Richland County School District One
Invitation for Bids: Meadowfield Elementary School Parking Lot Addition

Richland County School District One INVITATION FOR BIDS FOR CONSTRUCTION SERVICE AMENDMENT No. 1	Solicitation # Date Issued Procurement Officer Phone E-mail Address	2026-010 JUNE 22, 2026 Brittany Green 803.231.7052 brittany.green@richlandone.org
--	---	--	--

Solicitation No. 2026-010
Meadowfield Elementary School Parking Addition
Amendment No. 1

THIS AMENDMENT IS TO ANSWER QUESTIONS FROM OFFERORS.

C1.0
Sheet Number
May 12, 2025
Date

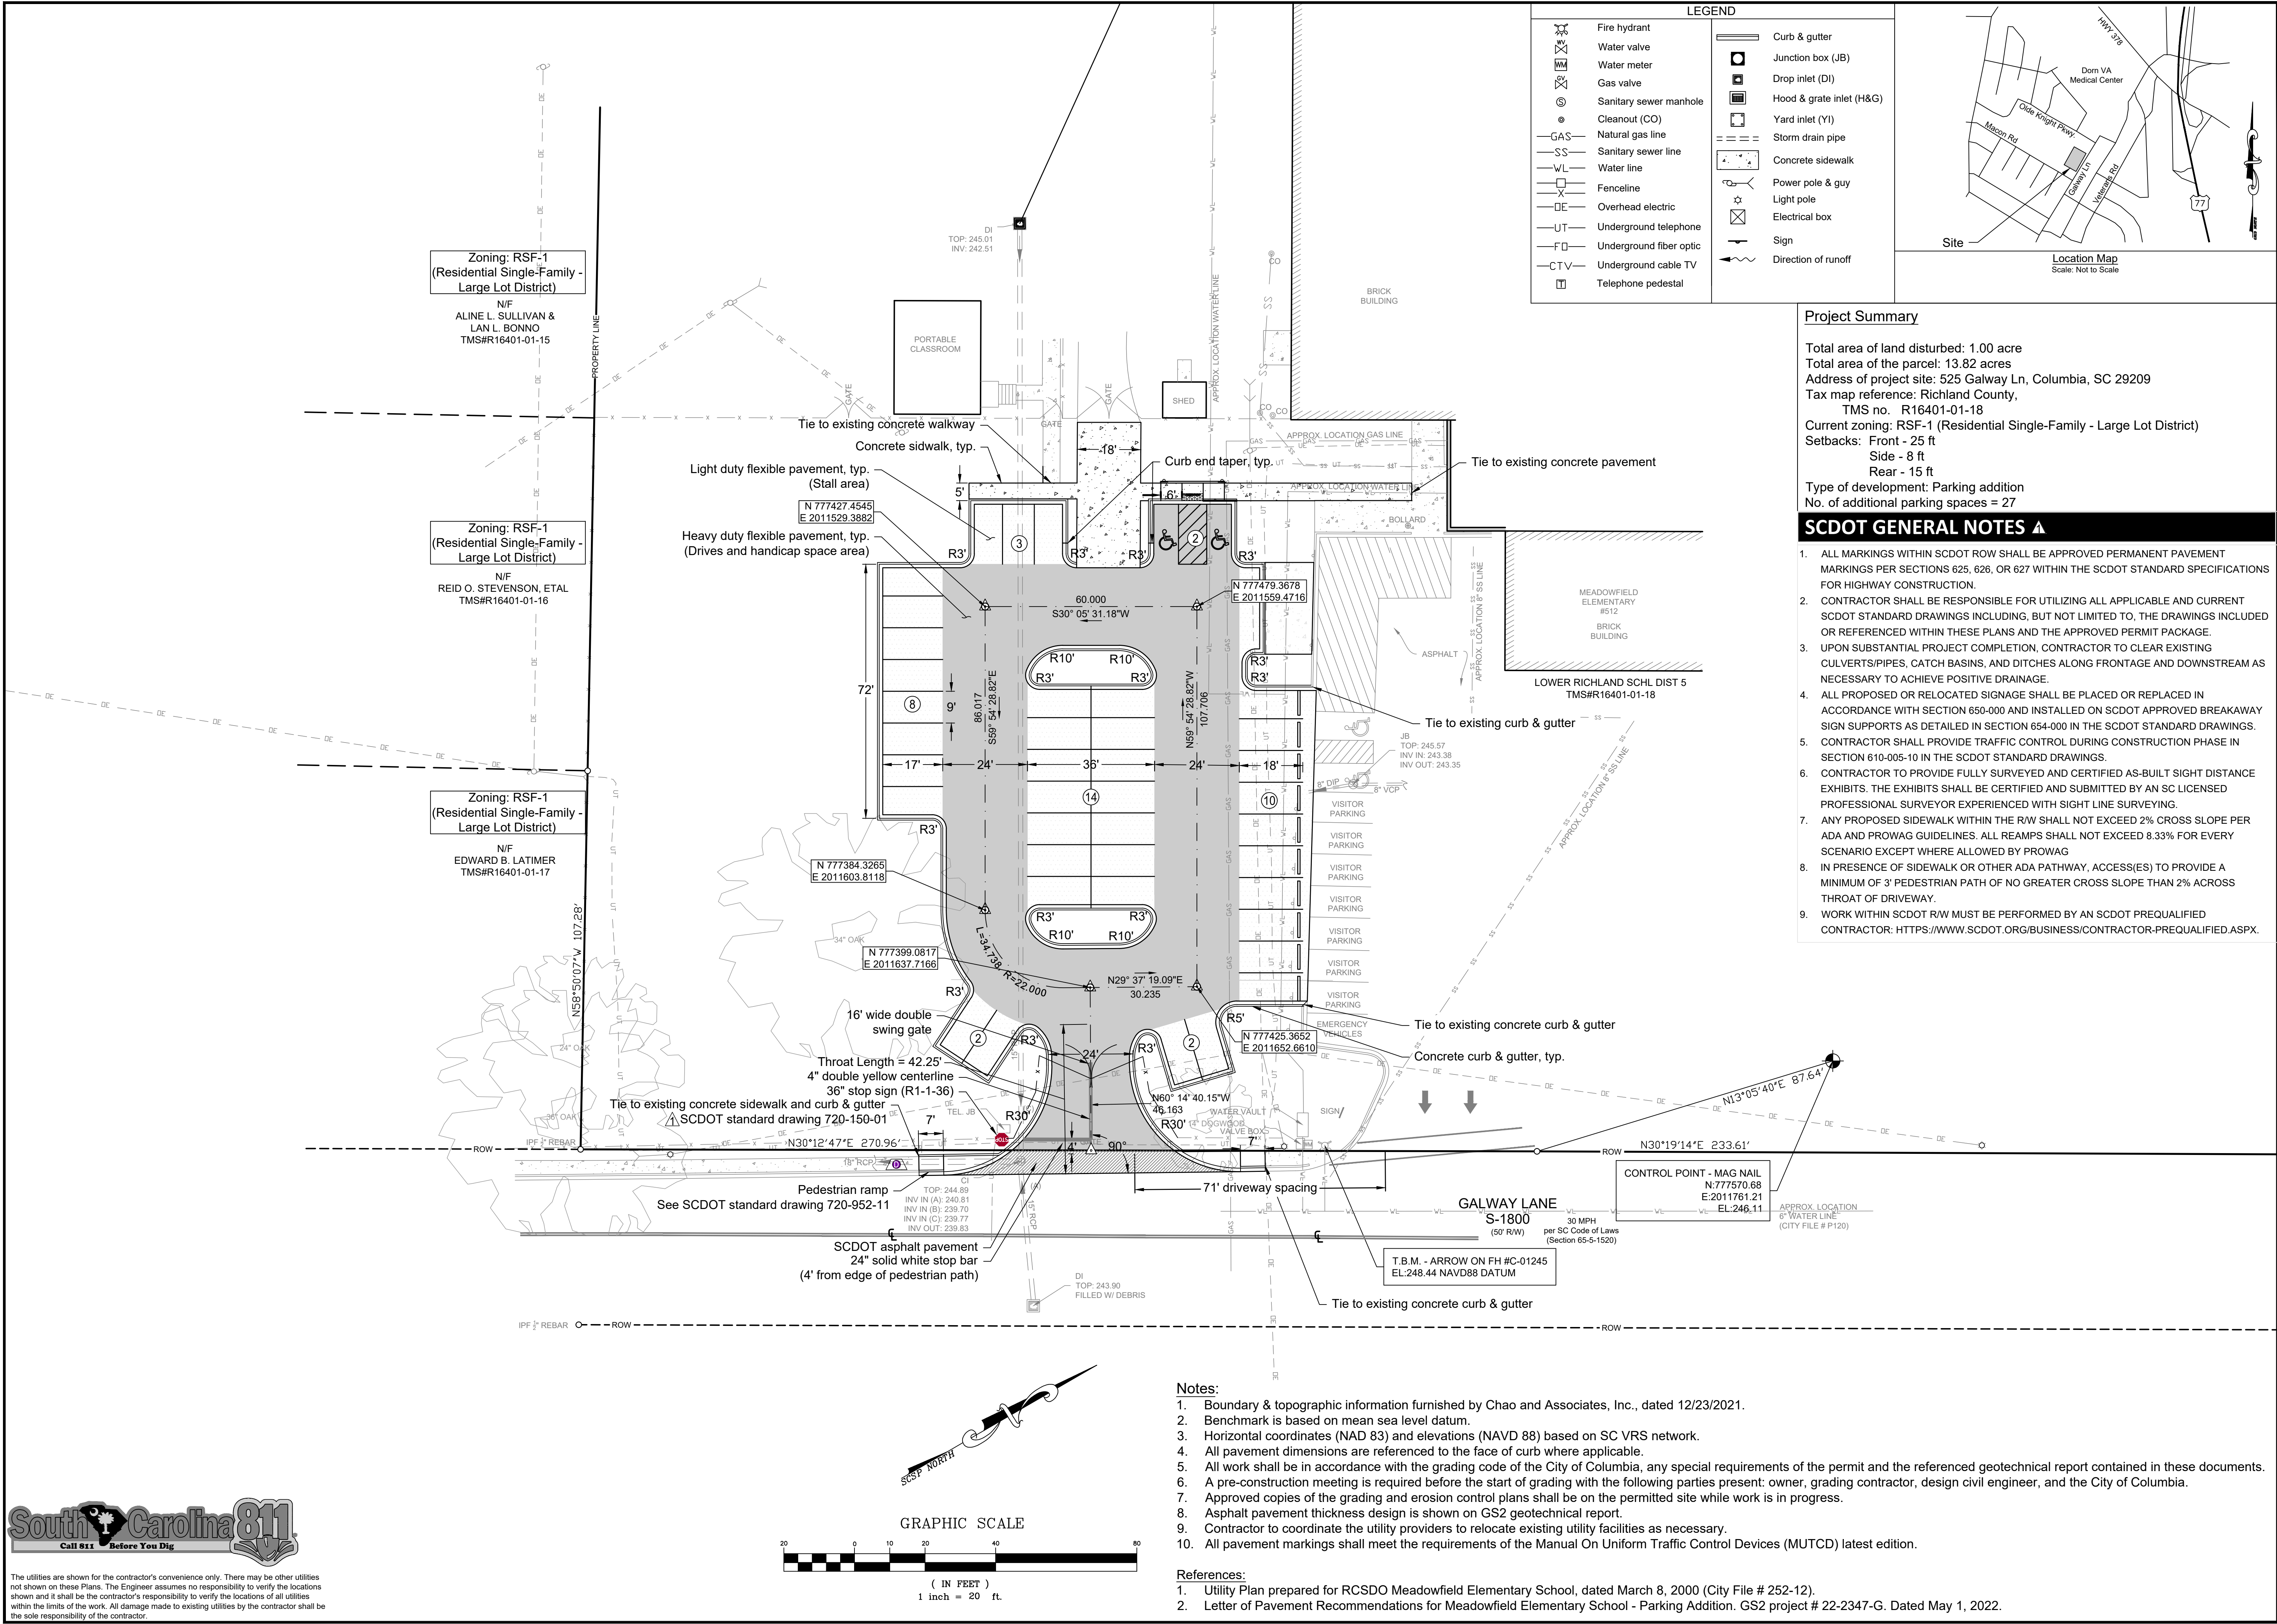
Q7: The demo page says to protect existing storm drain for the 15", but is in line with proposed line C. Shouldn't this line be removed in the demo plan?

A7: Existing 15" storm drain is to be removed. See revised plans.

Grading & Drainage Plan
Meadowfield Elementary School Parking Addition
Prepared for:
Richland County School District One
In the City of Columbia, Richland County, SC

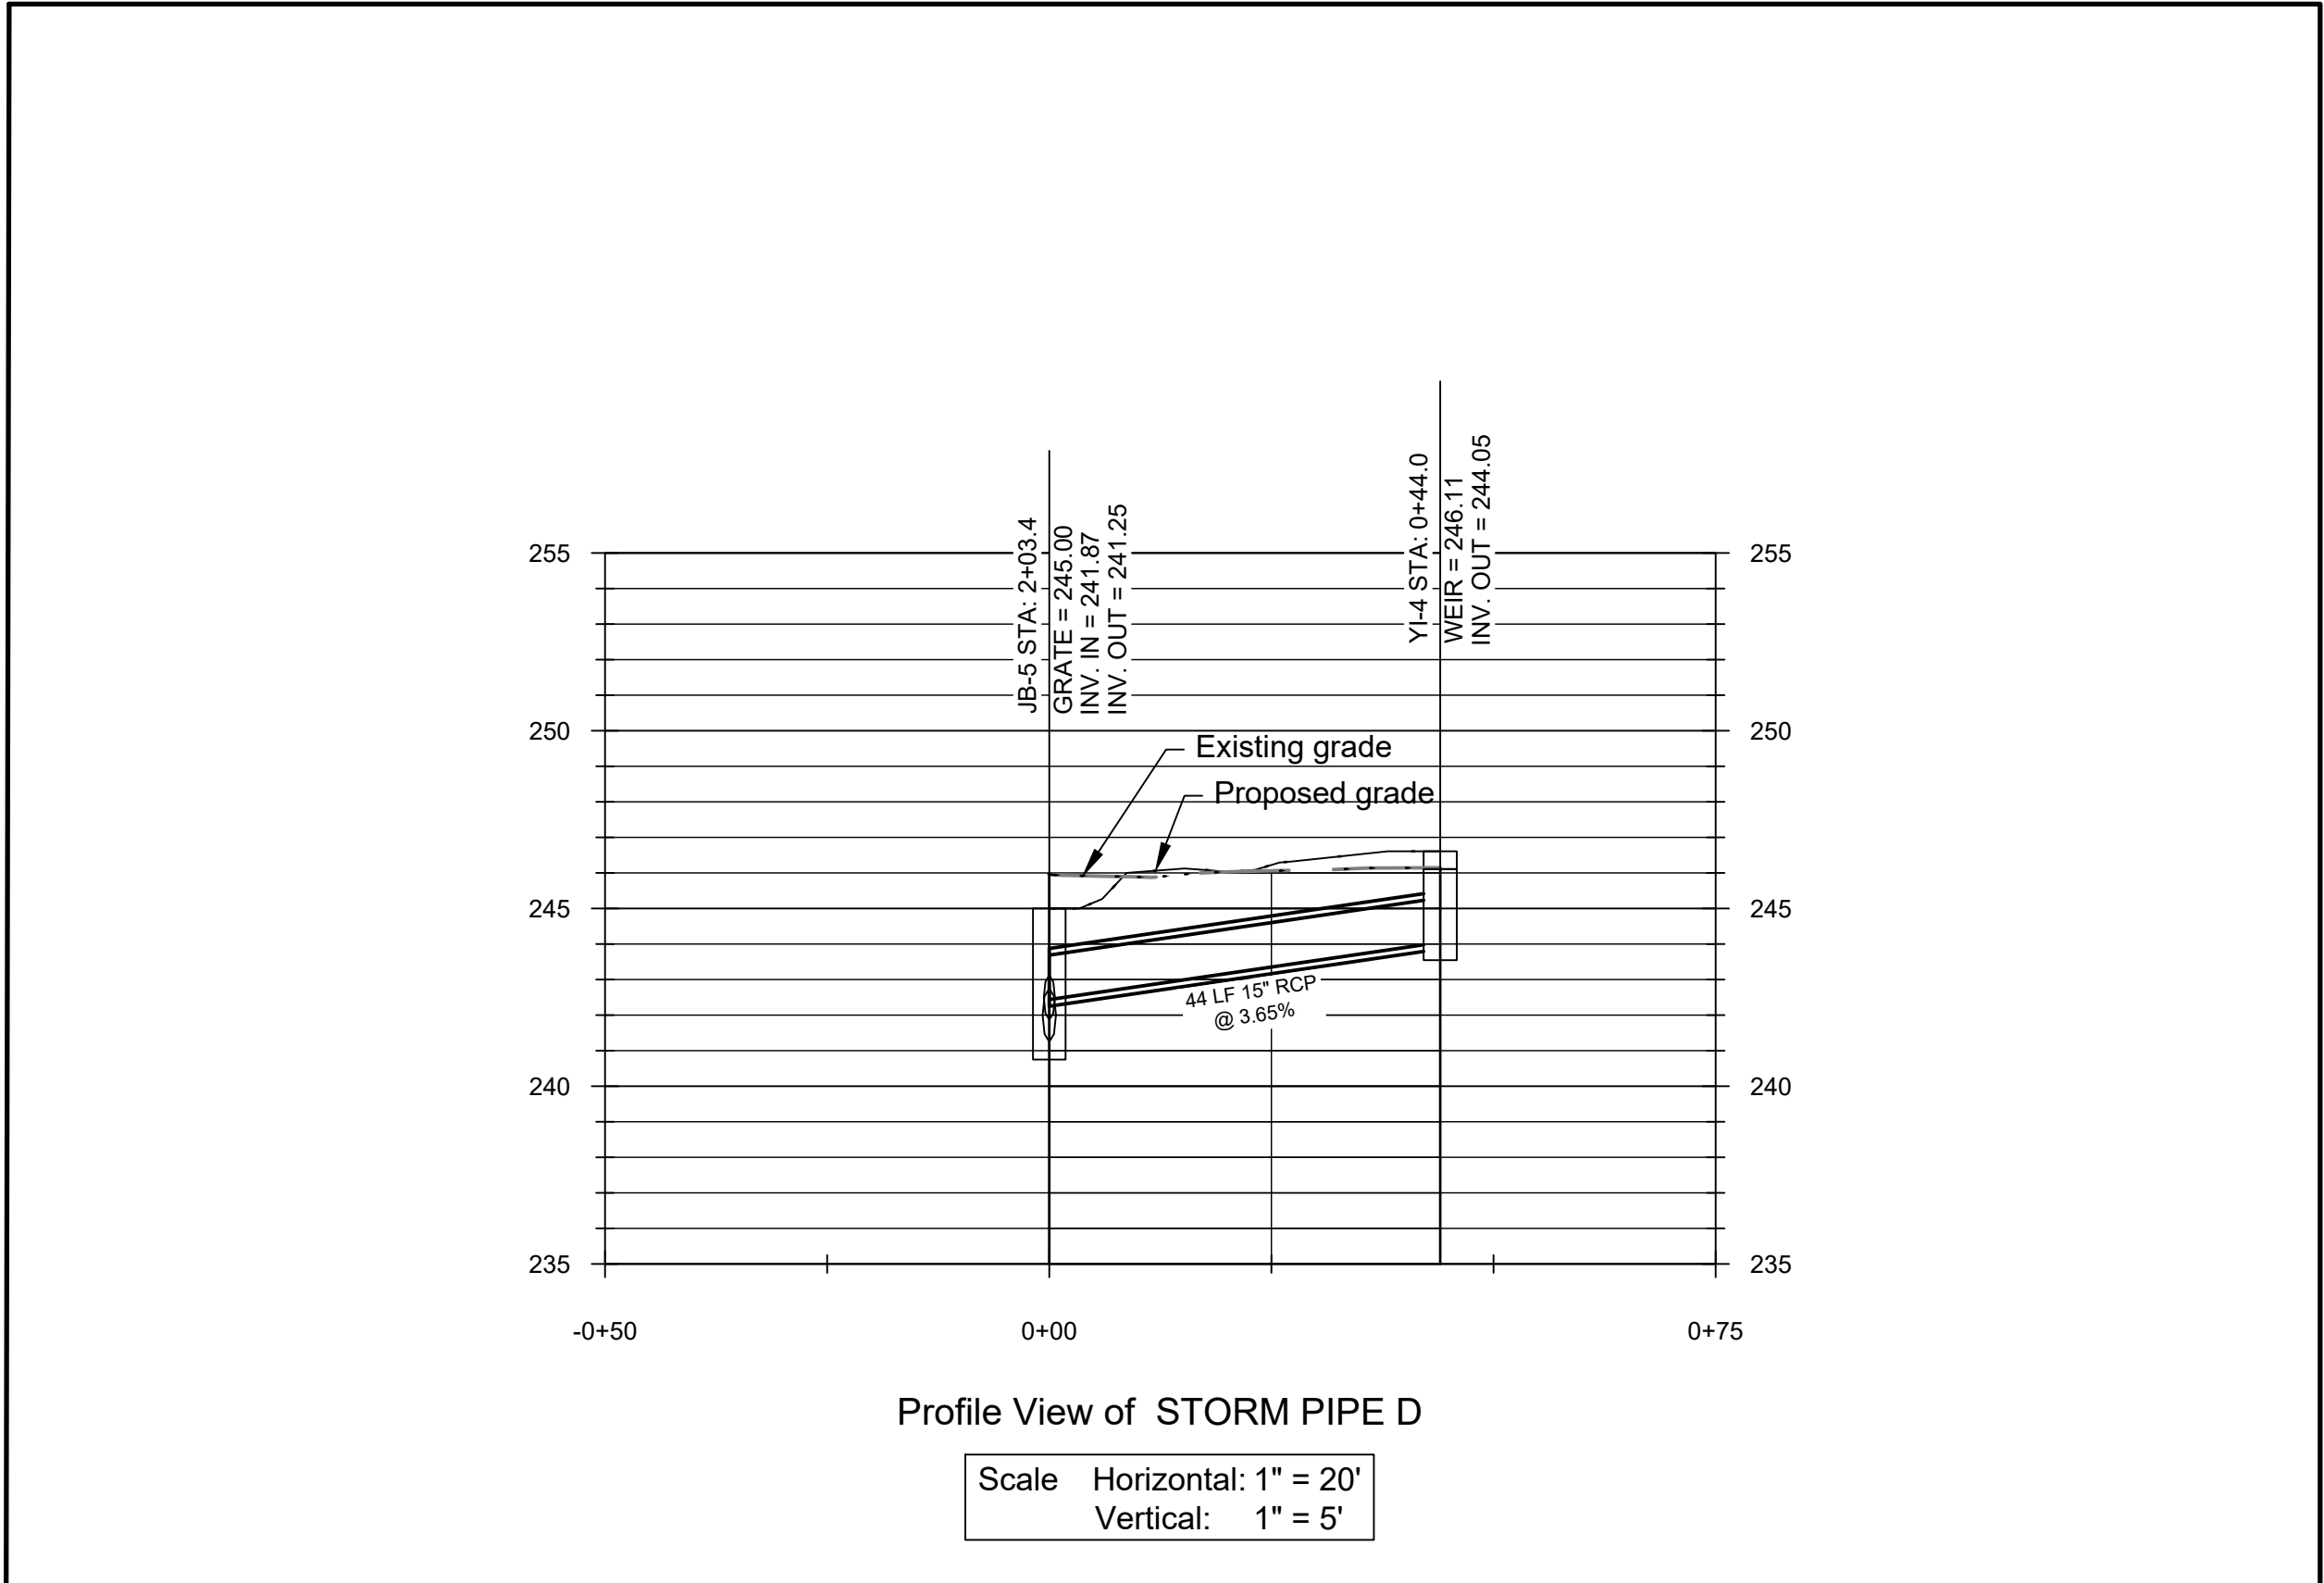
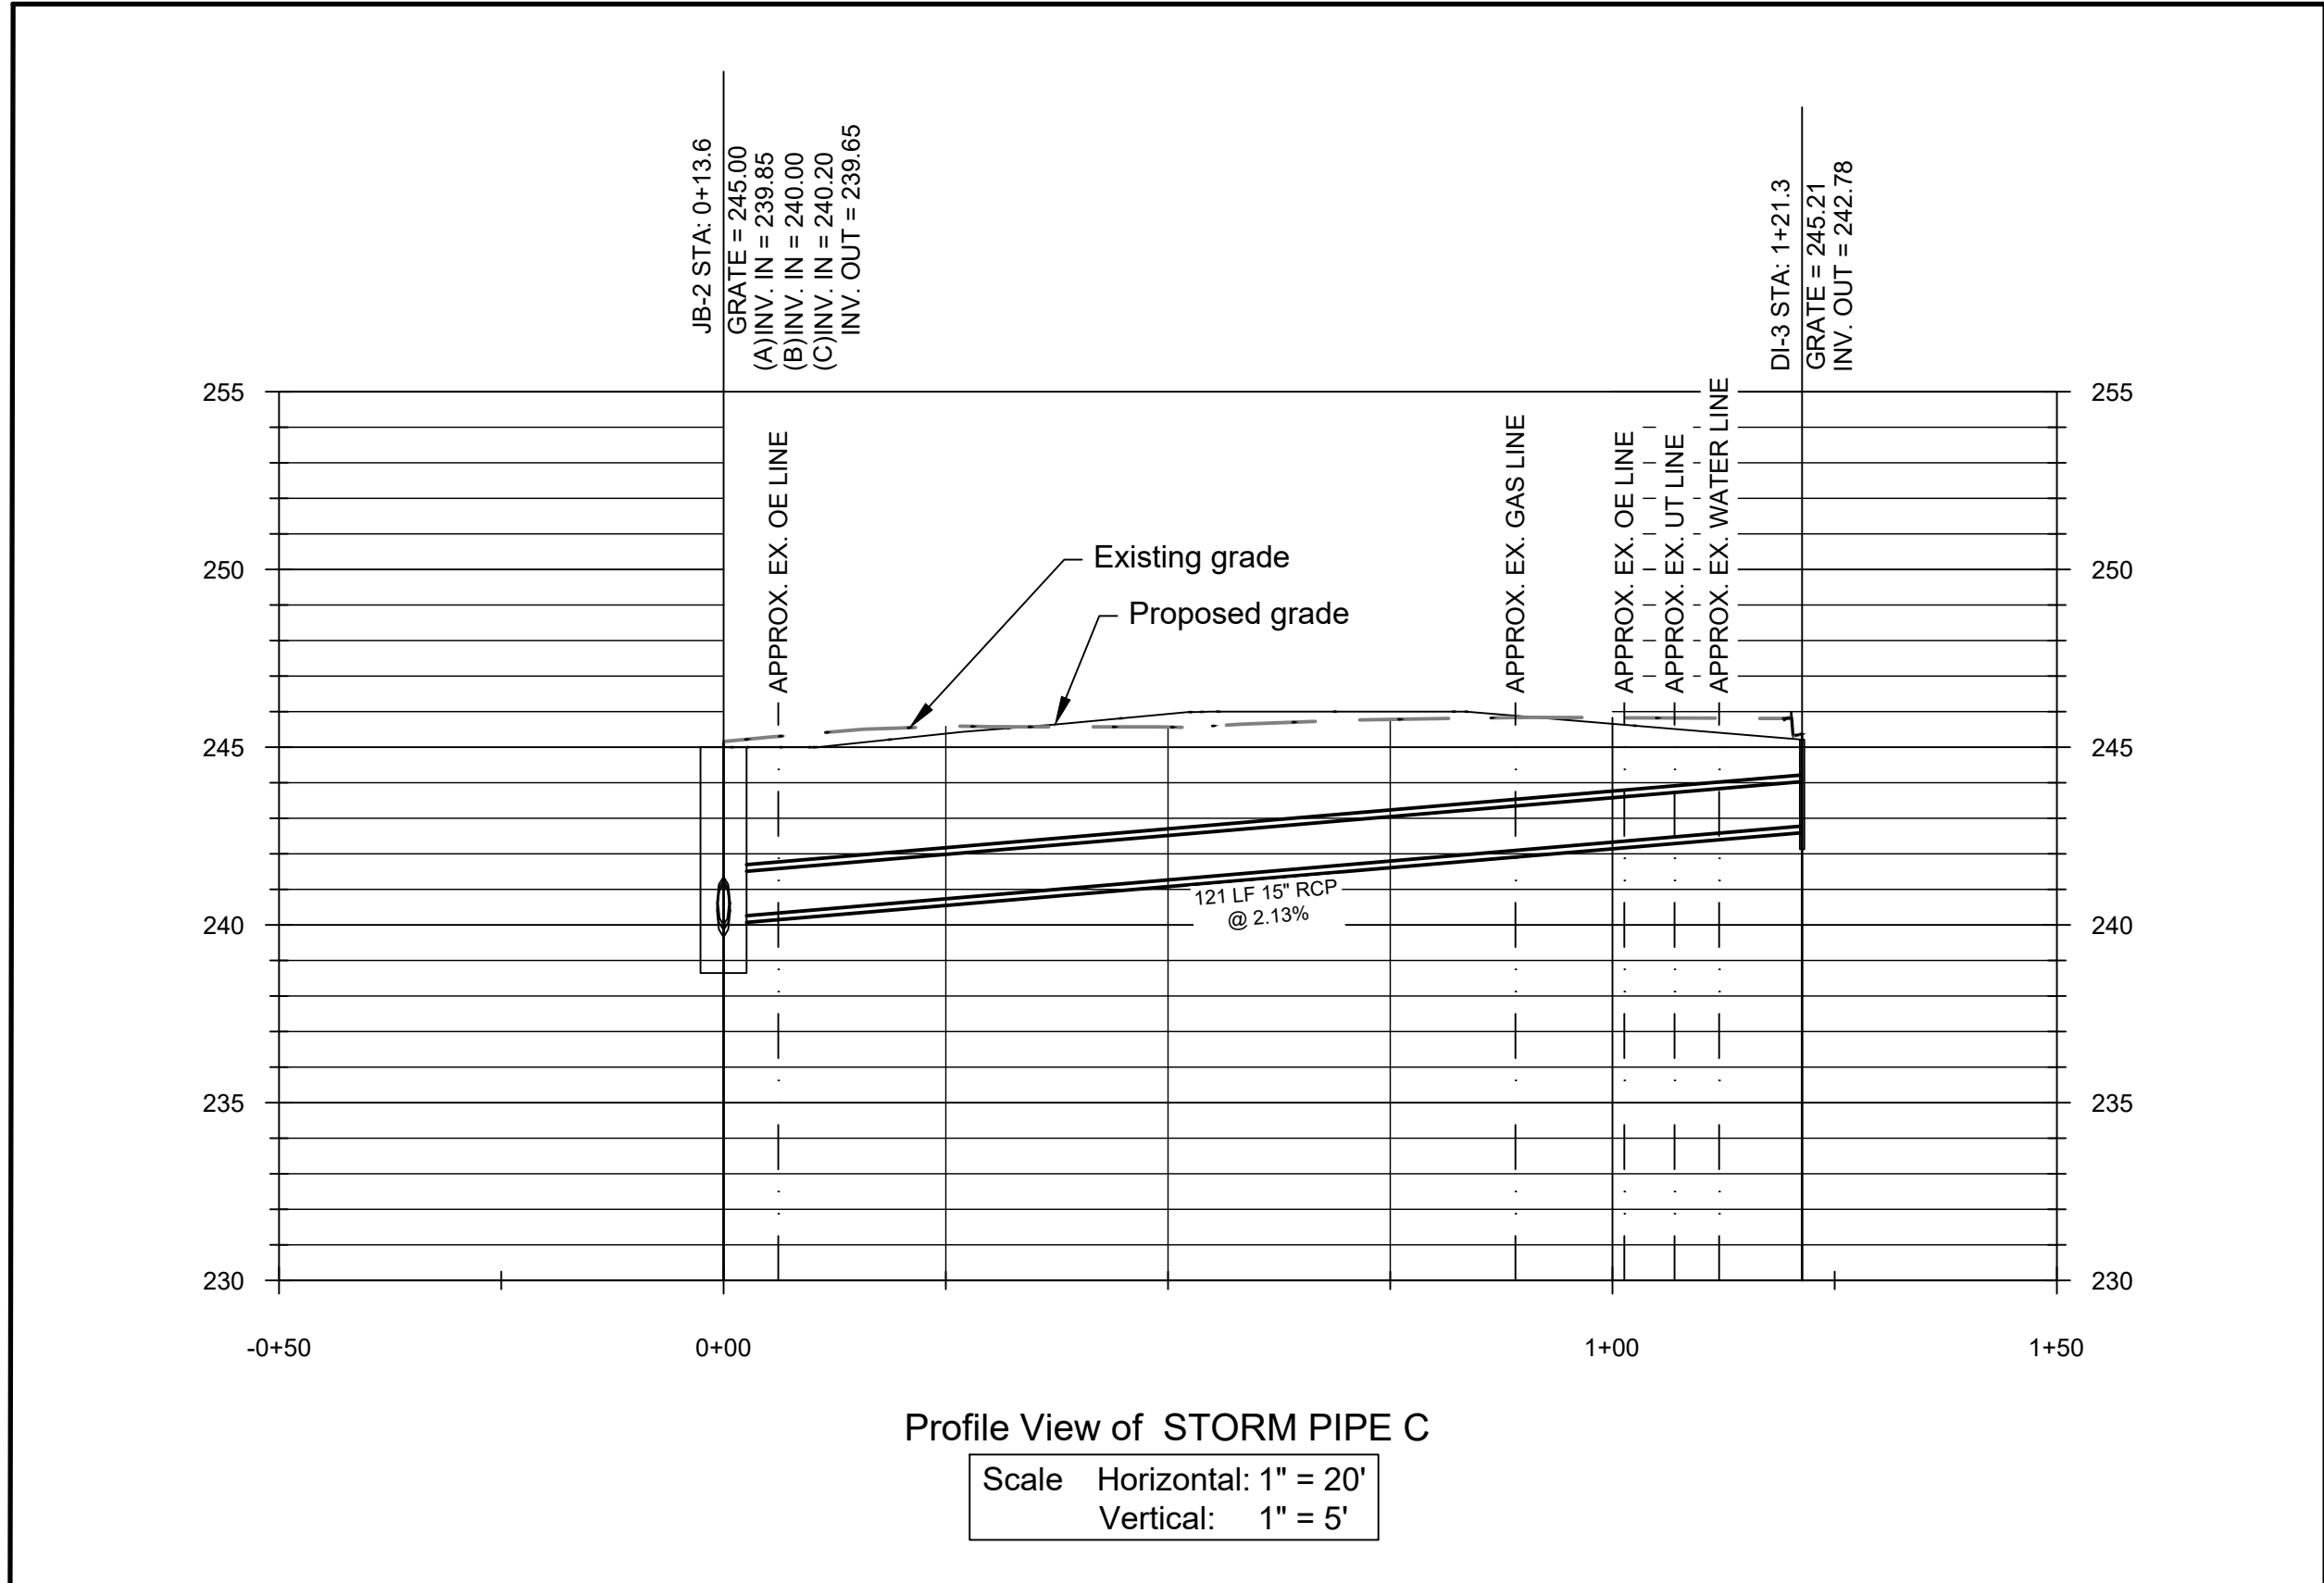
Q8: Sheet C3.0 shows the contractor is to install a type 16 out by Galway Lane but shows the structure as existing on C1.0. I did not see an existing structure on the site. So is the contractor to install a complete Type 16 (doghouse) in this area?

A8: Yes, a new Type 16 doghouse will be required.
